UNITED STATES PATENT AND TRADEMARK OFFICE

APPLICATION NO.	FILING DATE	FIRST NAMED INVENTOR	ATTORNEY DOCKET NO.	CONFIRMATION NO.
10/800,700	03/16/2004	Noboru Chosei	P69585US0	1775

Office Action Summary

DETAILED ACTION

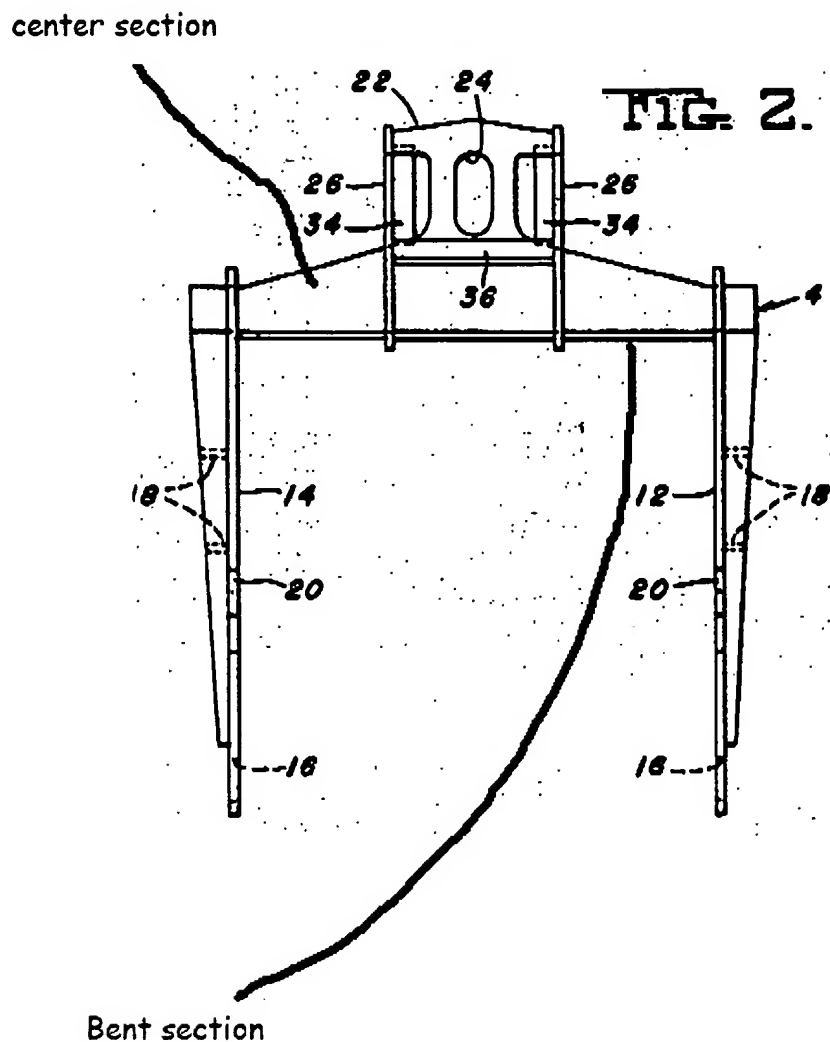
Larson discloses an engine driven work machine (motor 3 is an engine, pump 4 is a work machine) comprising a transportable structure attached to a pipe frame (10), a sling fitting (60) being provided above the pipe frame and connected thereto.

The sling fitting of Larson is not rotatably connected to the pipe frame.
